FAQ Number **08-0054**

FAQ Title **Demonstrating Compliance with Chapter 4 of NFPA 805**

Plant: Oconee Nuclear Station  
Contact: David Goforth

- Markup of NEI 04-02 Section 4.3.2, Nuclear Safety Performance Criteria Transition Review, and
- Replacement for Appendix B Section B.2.2, Establishing Compliance with Chapter 4 of NFPA 805.

Figure 4-3 - Fire Area ~~by Fire Area~~ Transition Process (Simplified)

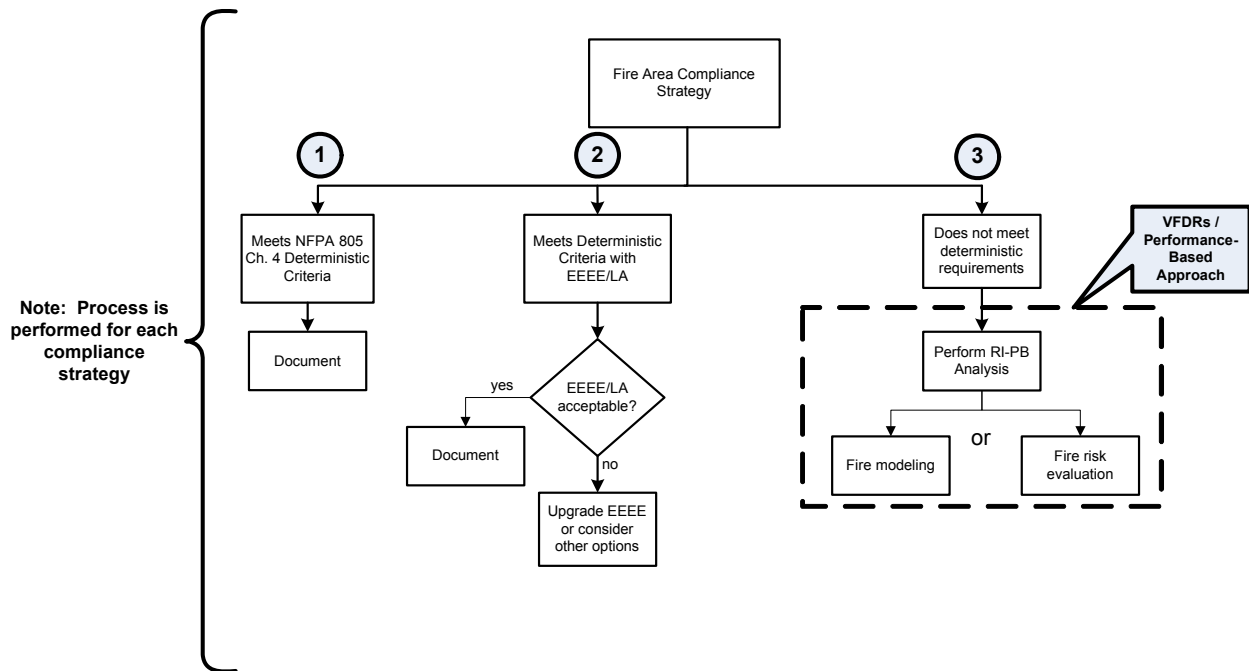
A simplified flowchart of the fire area ~~by fire area~~ transition review is provided as Figure 4-3 below.

The review is intended to identify and document ~~how~~ compliance strategies for each fire area:
